CALIFORNIA COASTAL COMMISSION

**STAFF REPORT: DE NOVO**

APPEAL NO.: A-4-OXN-03-034

PROJECT LOCATION: 1041 Mandalay Beach Road (Oxnard Shores), Oxnard (Ventura Co.)

EXHIBIT NO. 8
APP. NO. A-4-oxn-03-034
WEST ELEVATION

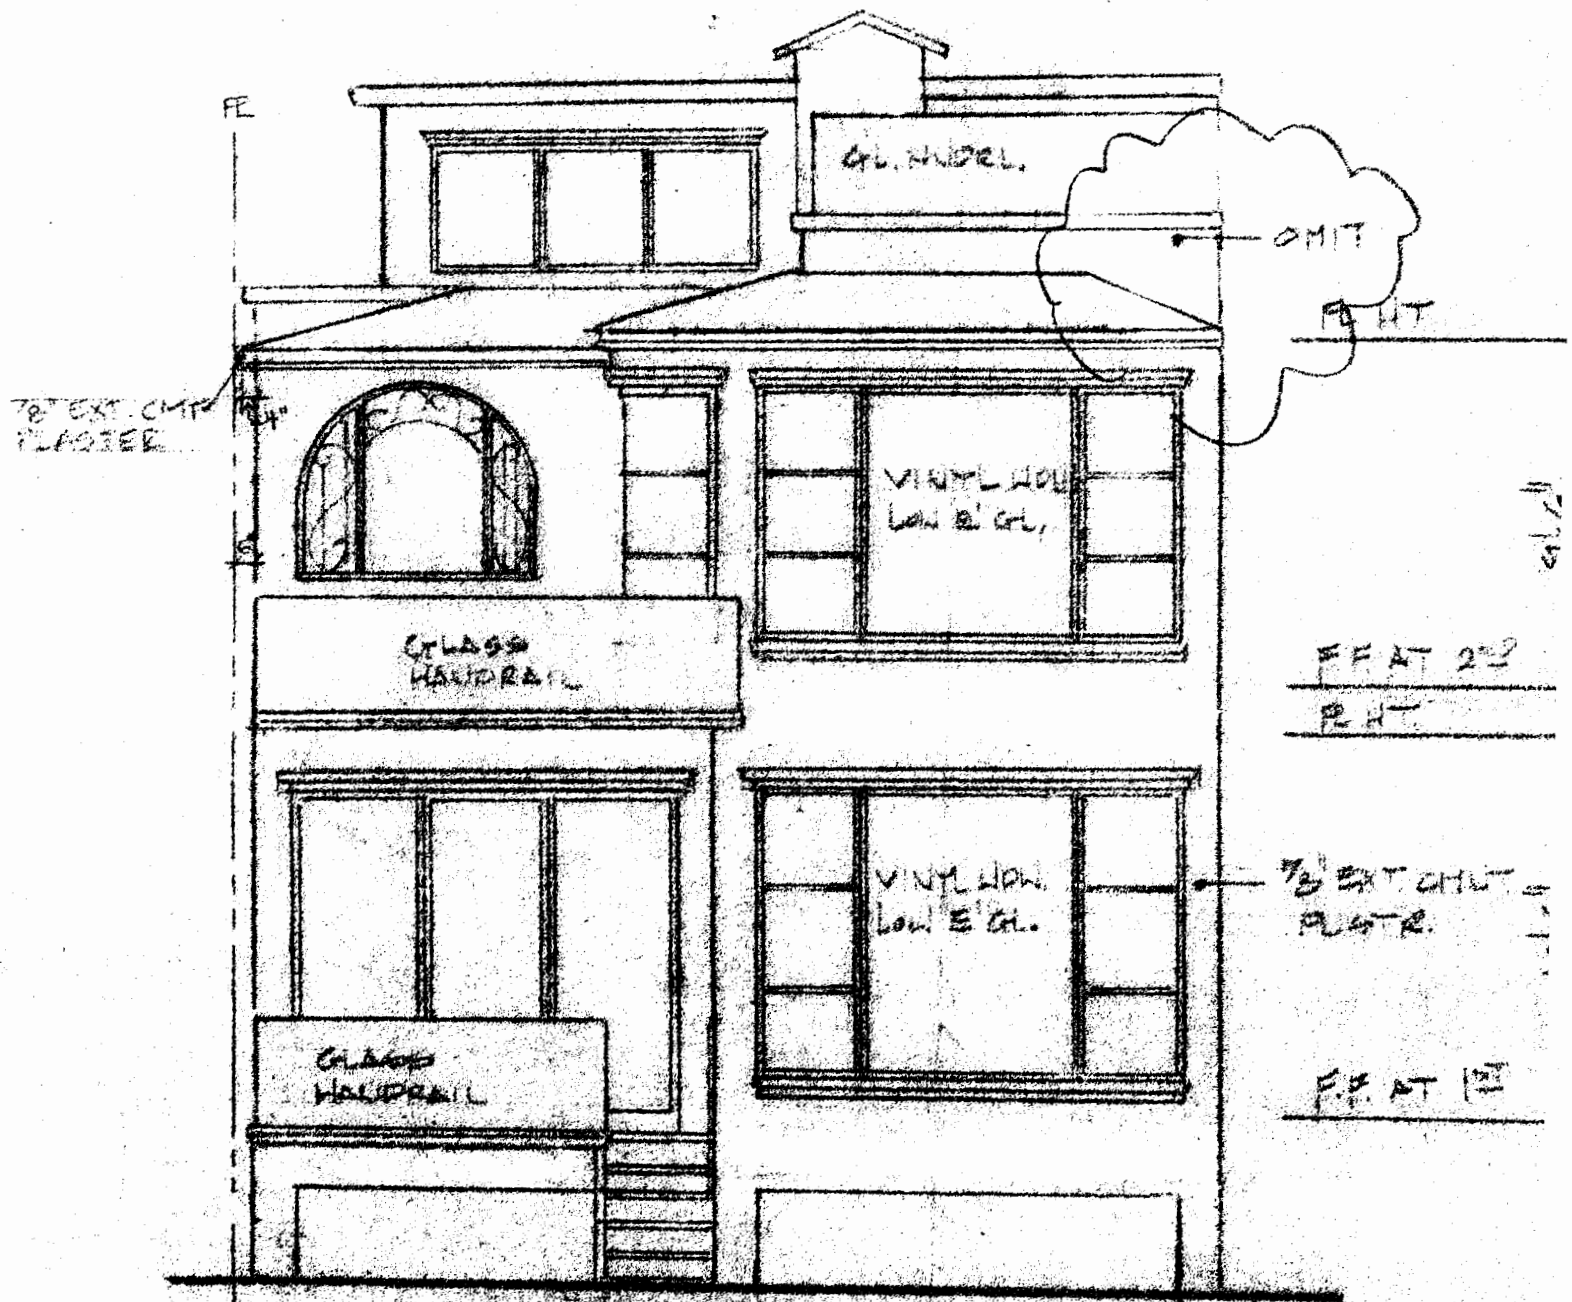
The applicant and the City submitted evidence that the applicant revised the proposed project plans subsequent to the City's approval in response to the appeals filed with the Coastal Commission. The project was revised on April 23, 2003 to delete the landing and staircase within the side yard setback area (Exhibit 2). The applicant further revised his plans in order to be sensitive to his neighbors' concerns, modifying the elevations to omit corbals and an overhang on the seaward face of the residence (Exhibit 3). See Exhibits 4-11 for proposed project plans.

VIEW FROM PUBLIC SIDEWALK

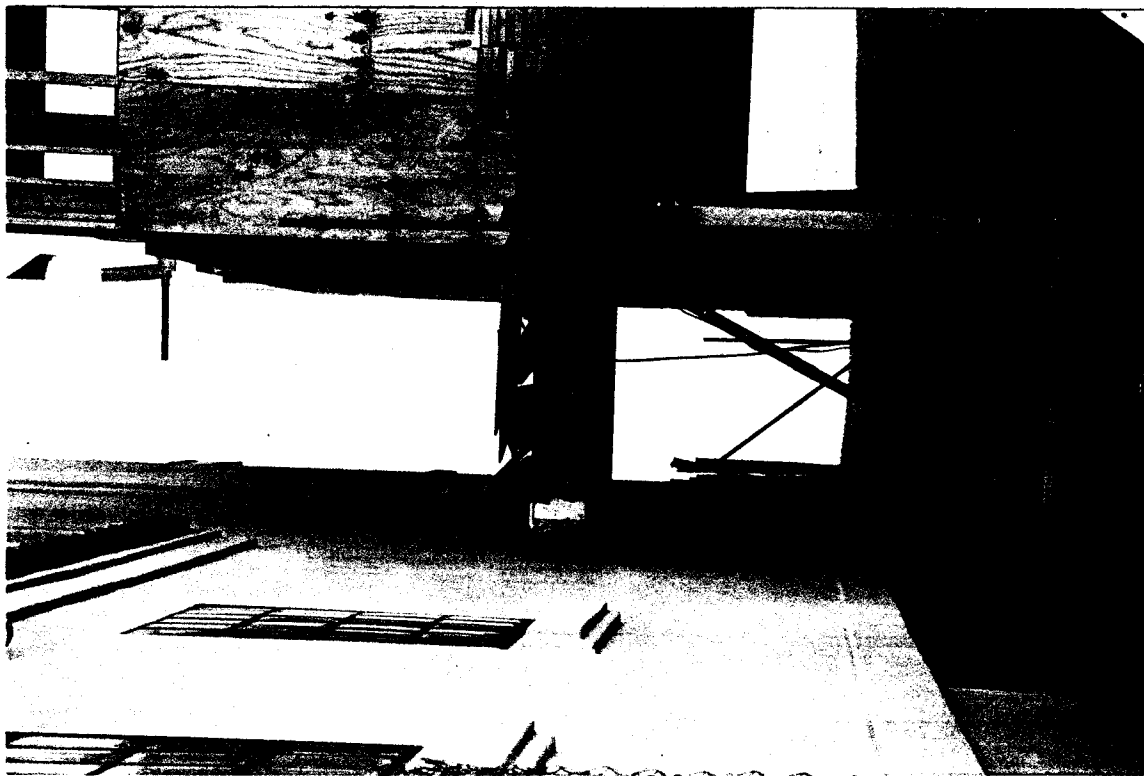
1. The structure fails to provide physical access to the shoreline since the public would have to climb at least ten steps up to the top of the landing and then descend approximately ten additional steps to get to the beach and shoreline.
2. The structure fails to protect views from the public road.

As noted above, the project has been revised to delete the approved stairway, thus, the proposed development does not involve an encroachment into the side yard setback area. As such, the appellants' contentions are no longer viable in relation to the stairway structure. Further, the impacts of the proposed development on public access and visual resources are addressed below.
